Office Action Summary

09/891,310

SUZUKI, MASAHIITO

DETAILED ACTION

Scan register: (circuit design) A digital logic circuit which can act either as a flip-flop or as a serial shift register and which is used to form a scan path. The most common design is a multiplexed flip-flop:

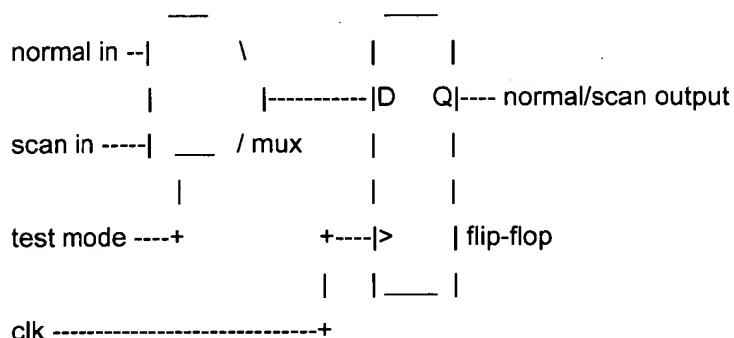
The definition of ‘scan register’ per computer dictionary online is listed below:

The addition of a multiplexor (mux) to each flip-flop's input allows operation in either normal or test mode. The output of each flip-flop goes to the normal functional logic as

well as to the scan input of the next multiplexor in the scan path. The other common design is level-sensitive scan design (LSSD). (1995-02-14)

The examiner fails to see that this (above) limitation adds any novelty to the independent claims.
